City of Portland, Maine - Building or Use Permit Application

Permit No: 0-051144	Issue Date: 2 9 2001	CBL: 430 A019001, 22, 24
------------------------	-------------------------	-----------------------------

BUILDING PERMIT REPORT

DATE: 18 MAY 2001 ADDRESS: 20 Berwick ST CBL: 430-A-019
 REASON FOR PERMIT: To Construct a 14'x33' addition
 BUILDING OWNER: A.W. Chapman

Front

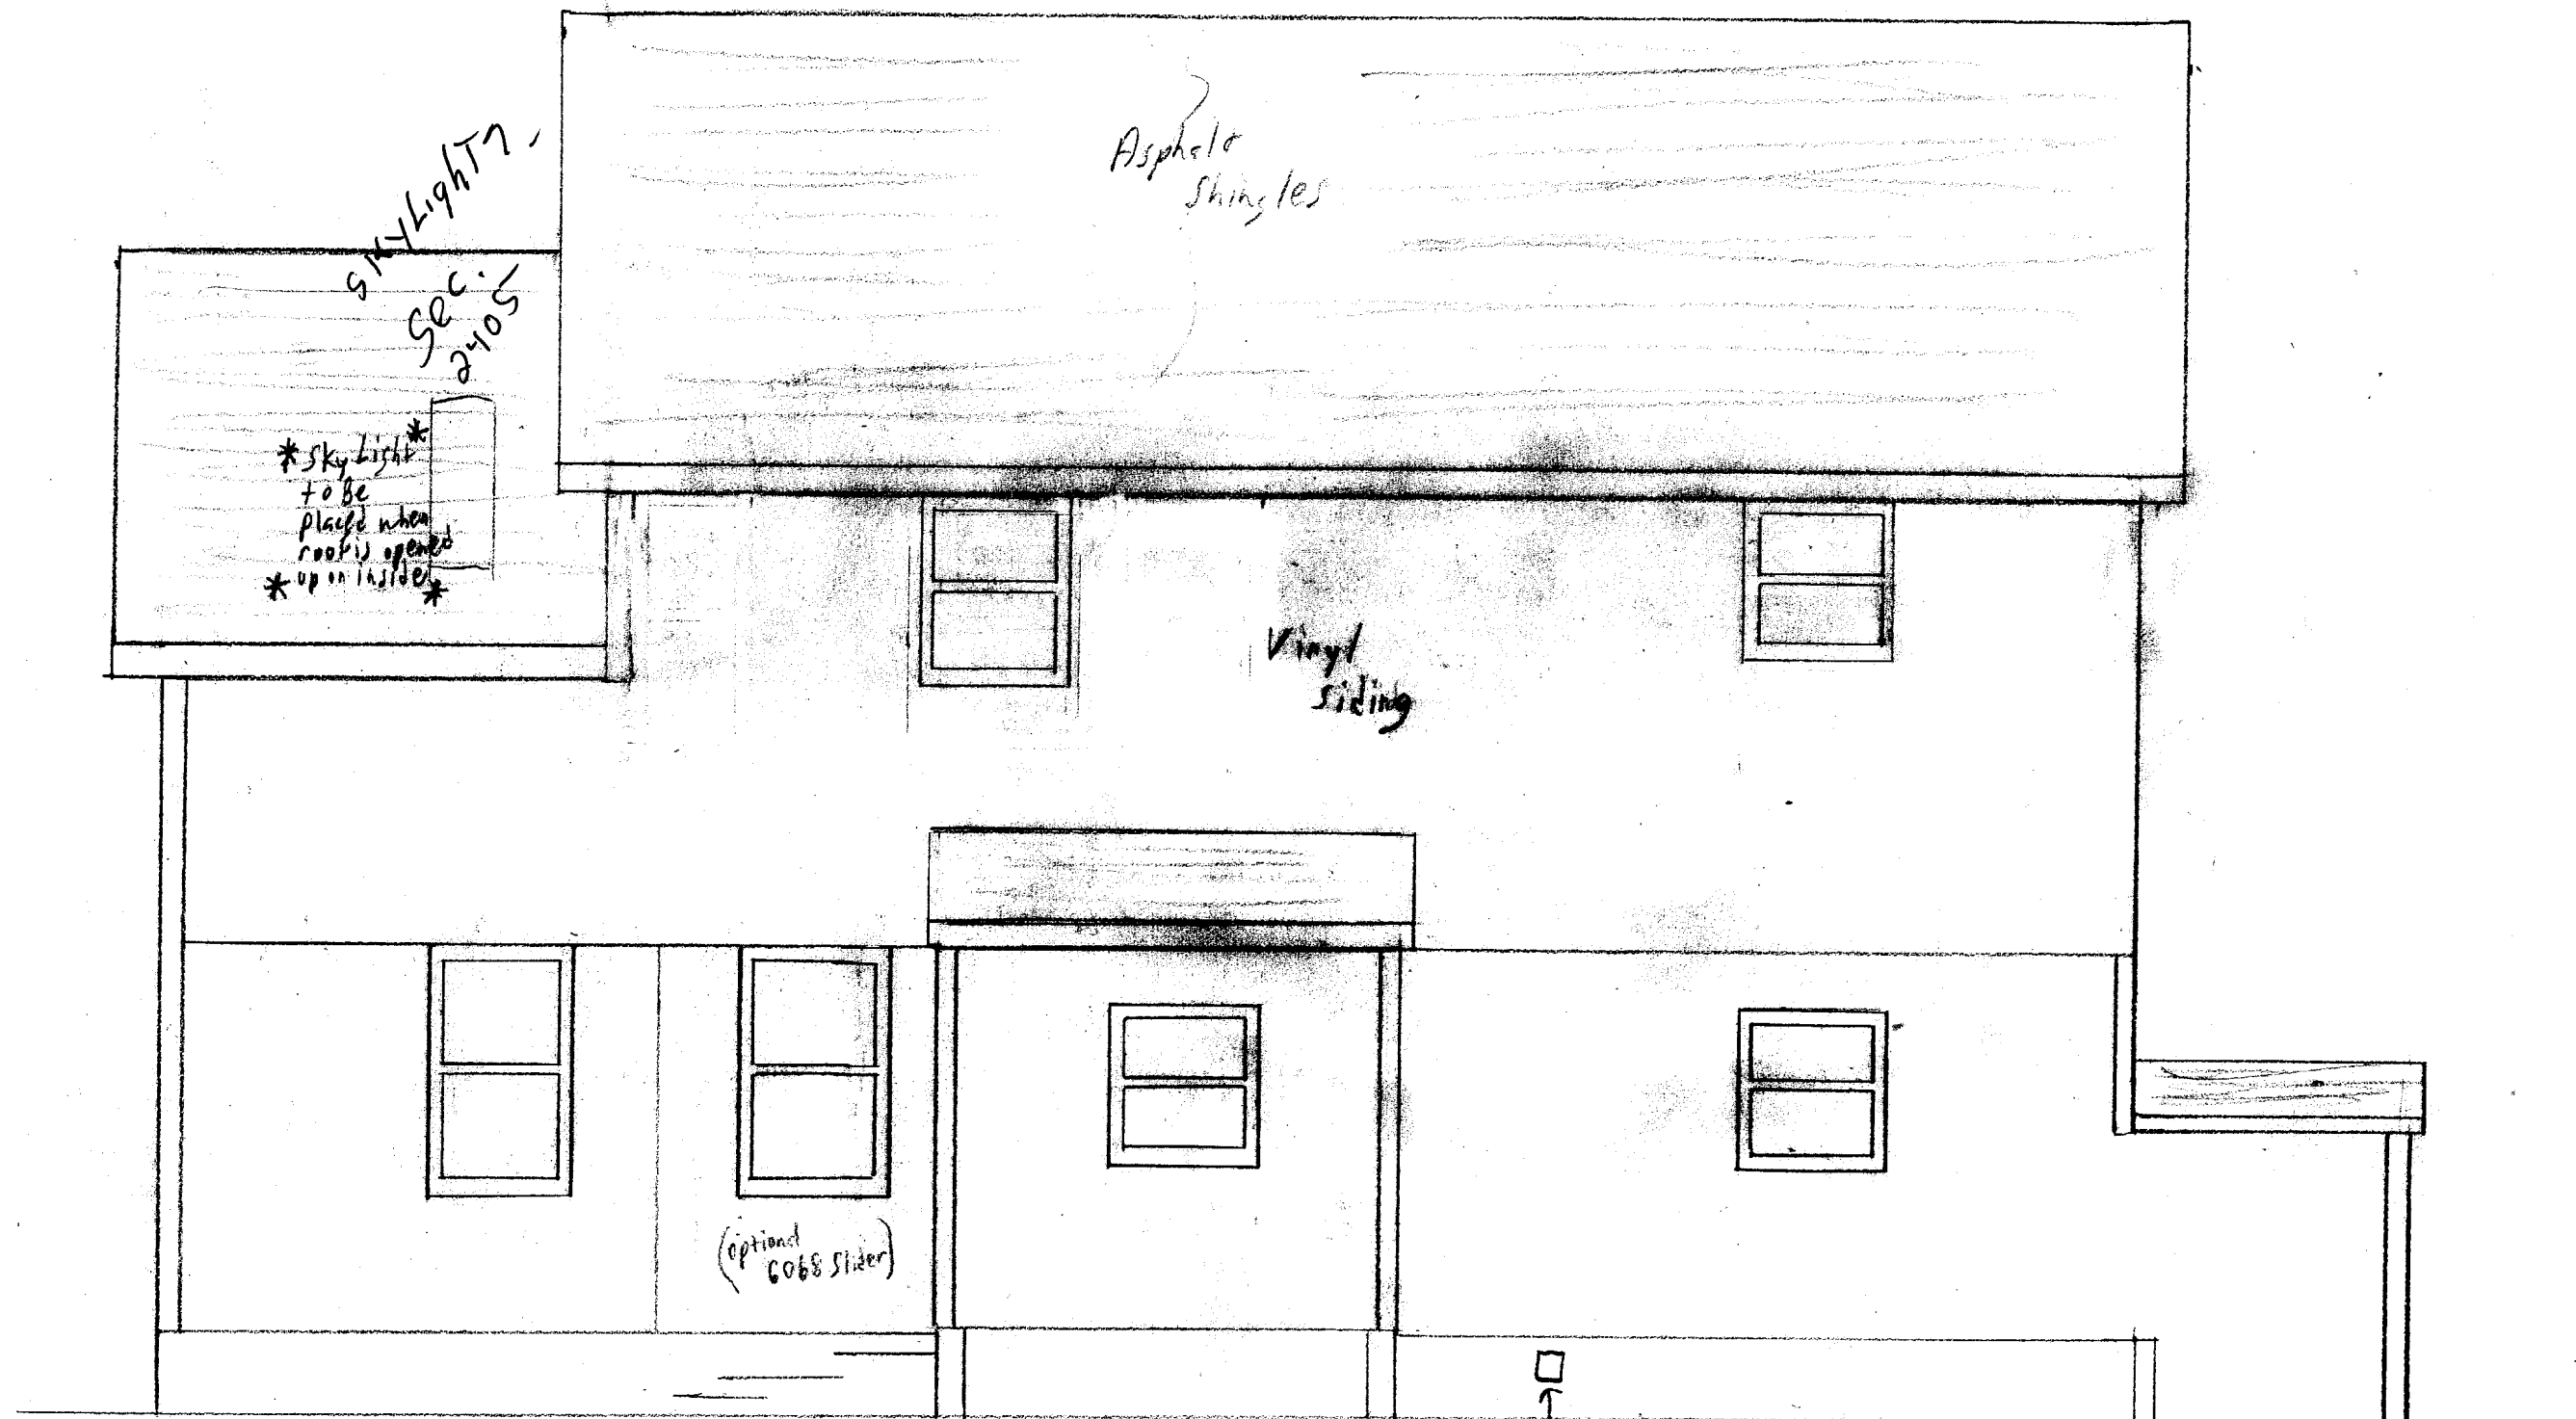
Handrails
sec. 1022.0
